# SERVICE LETTER

**SUBJECT: HONEYWELL SERVICE BULLETIN 131358-21-4179**

This sheet transmits Revision 1 to Service Bulletin Number 131358-21-4179.

AIR CONDITIONING - AUXILIARY VOLUME TANK - Check and Repair of Auxiliary Volume Tank Part Numbers 131358-2 Series 1 and 131358-3 Series 1.

Modification/Configuration History Diagram  
Figure A-1

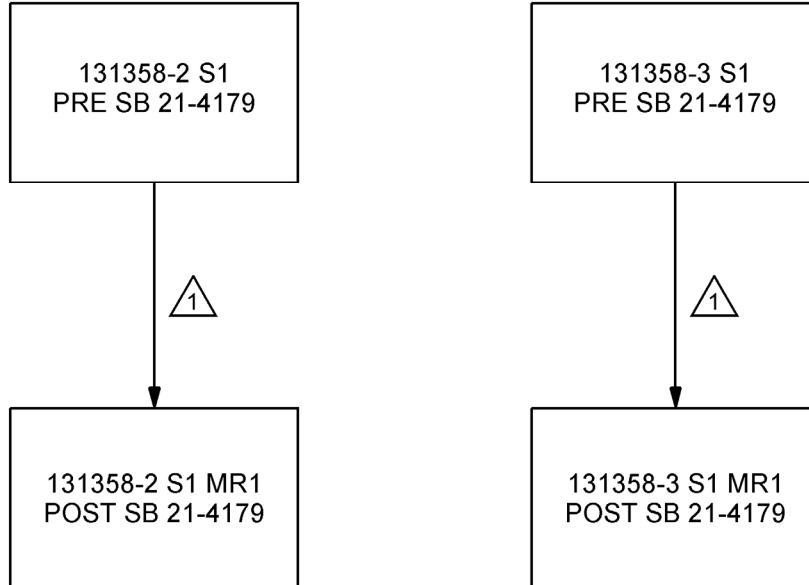
Family Tree Chart of Modification/Configuration History. See Figure A-1.

AFFECTED SERIAL NUMBERS ONLY.
